Subject: Response to Conditional Requirements in First Amendment
Polychlorinated Biphenyls, Toxic Substances Control Act (40 CFR
761.61(c)) - USEPA Conditional Approval of "Remedial Action Plan"
Former Sunkist Citrus Processing Plant
616 E. Sunkist Street
Ontario, California

The facility which is the subject of these document and approvals is the former Sunkist Citrus Processing Plant (Sunkist Site), located at 616 E. Sunkist Street in Ontario, California.

Figure
No.
1

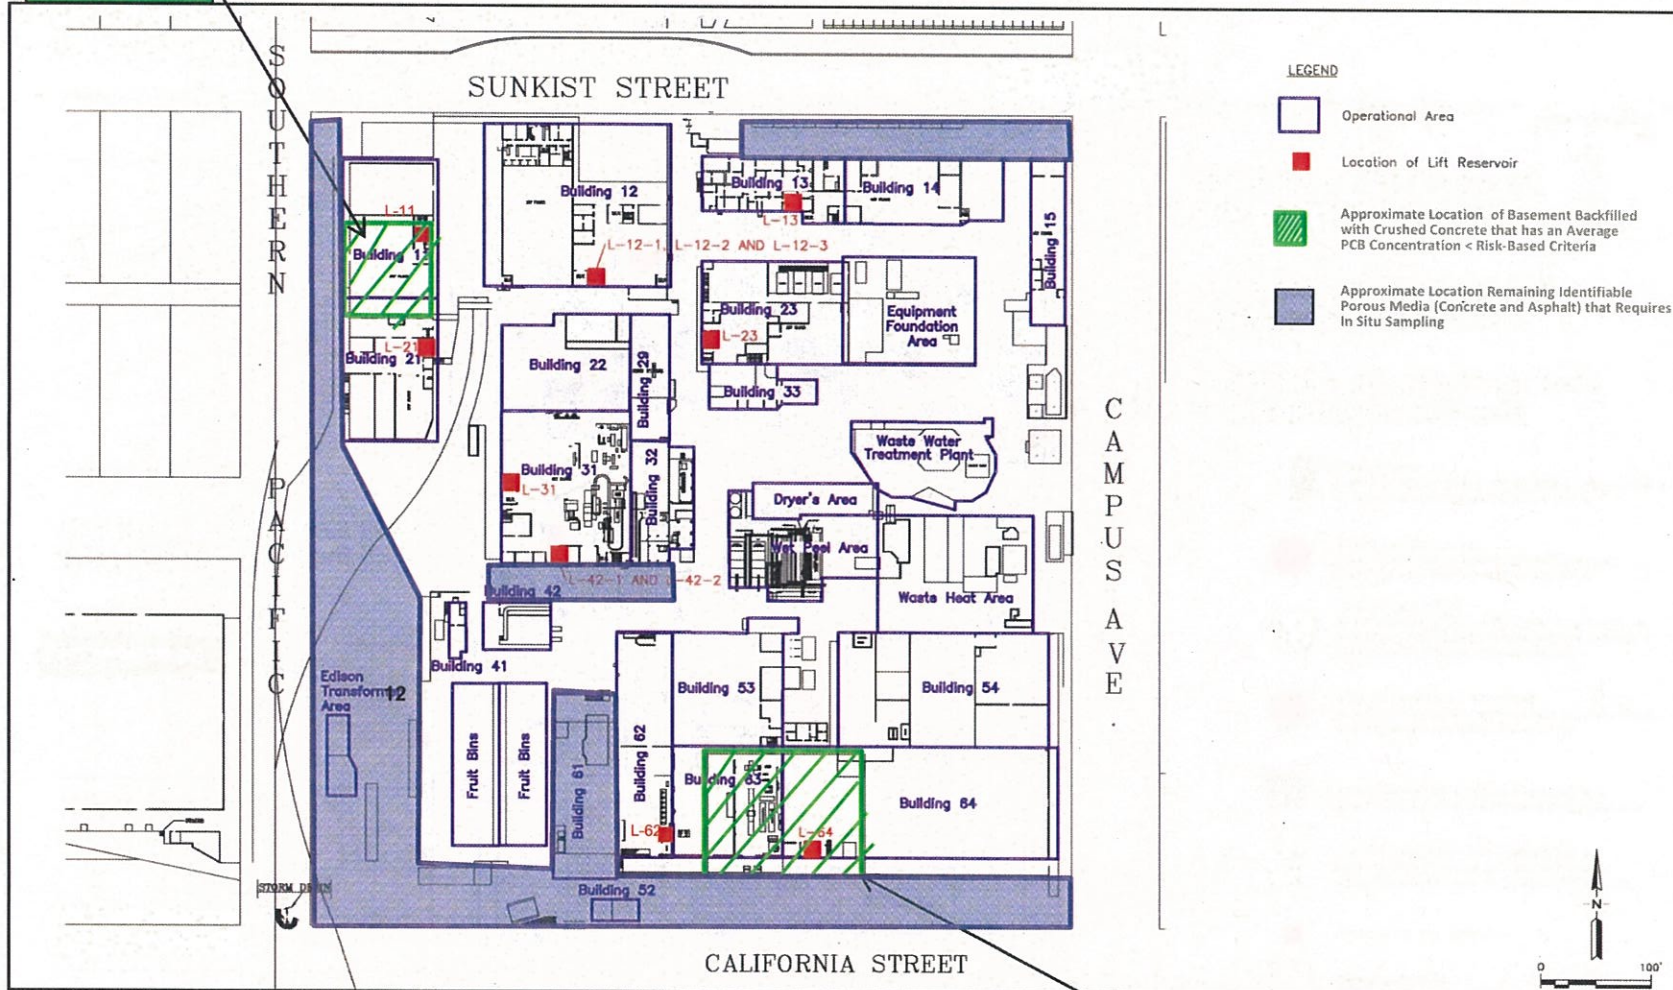
Additional EPA Comment 3: Condition C.5 (Stockpile Sampling and Off-Site Disposal (Section 4.2.2 of the RAP). Condition C.5 applies to existing concrete stockpiles and to stockpiles that may be generated as a result of removing from inside building basements crushed concrete that is already located inside the basements. Condition C.5 does not approve or facilitate generation of new concrete stockpiles except those stockpiles that may be generated due to the reasons explained above. If Buildings 12 and 15 have not been demolished yet, proper characterization of the concrete floors shall be conducted prior to demolition of those buildings to ensure that concrete to be crushed does not exceed the 4.5 mg/kg approved PCB cleanup level. Sunkist/BEC shall propose the sampling approach for concrete characterization before demolition of buildings and other concrete structures to be crushed.

Other than the concrete associated with Buildings 12, 15 and 31 and the Wastewater Treatment Plant (WWTP), the other known concrete and other

porous media in place is present along the eastern, southern and northern margins of the Site, in one east-west roadway structure, and as a slab that formerly underlay Stockpiles W-N and W-S. The areas of known remaining subsurface concrete and other porous media (primarily asphalt) are shown on Figure 1. The in situ sampling plan for these areas is described as follows.

Figure
No.
3

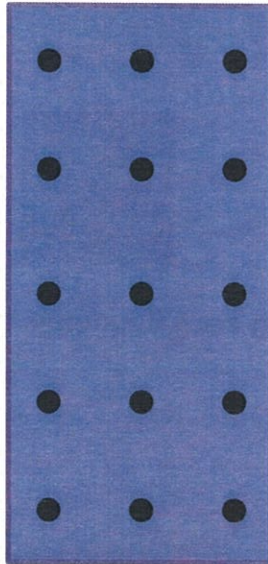
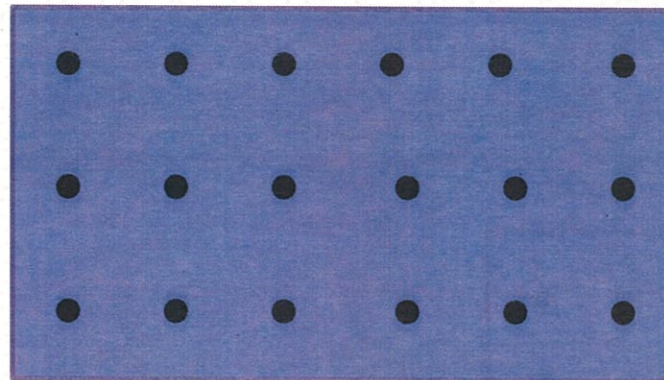
Additional EPA Comment 5: Condition C.7 (Soil beneath concrete stockpiles). No, the requirements in Condition C.7 apply to all concrete stockpiles. Therefore, soils beneath all stockpiles shall be properly characterized for PCBs and sample collection conducted as required in Condition C.7.

Given the size of the area underlying all of the stockpiles (approximately 1.5 acres) the implementation of sampling by the procedures defined in 40 CFR 761.289(b)(1)(i) and/or 40 CFR 761.289(b)(1)(ii), (b)(1)(ii)(A), (b)(1)(ii)(B), and (b)(1)(ii)(C) would require the collection of over two thousand individual samples that would then be composited into a series of samples for analysis. It would take a two man crew approximately 15 days to implement this type of sampling program. Given the size of the area to be evaluated, BEC is recommending that a discrete sampling program be implemented as an equivalent method. The scope of the discrete sampling program is defined on Figures 2 through 5. As shown, this sampling approach will result in the analysis of 69 discrete soil samples from throughout the entire area under the former crushed concrete stockpiles. The data generated via this approach is equivalent to that that would be generated by the procedures defined in 40 CFR 761.289(b)(1)(i) and/or 40 CFR 761.289(b)(1)(ii), (b)(1)(ii)(A), (b)(1)(ii)(B), and (b)(1)(ii)(C).

Figure
No.
6

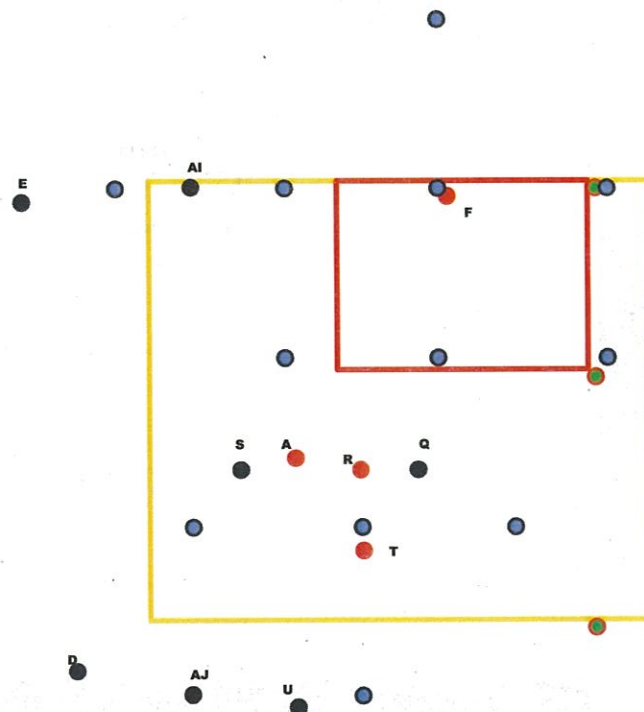
2. **Proposed soil sampling at WWTP.** USEPA is approving the proposed soil sampling beneath the concrete found to be contaminated with PCBs at the WWTP provided that one additional soil sample be collected 10 feet to the west of the soil sample location proposed outside the concrete area to be cut out and disposed of offsite as "non-TSCA" waste. The attached Figure 7 (Soil Sampling Under Impacted Concrete at WWTP) describes additional soil sampling to be conducted beneath concrete based on currently available concrete sampling results. Depending on the results of the additional concrete sampling to be conducted as required in Condition B.1 above, additional soil samples may be required.

Agreed and Noted. Please see the attached Figure 6, which shows the location of the additional soil sample.
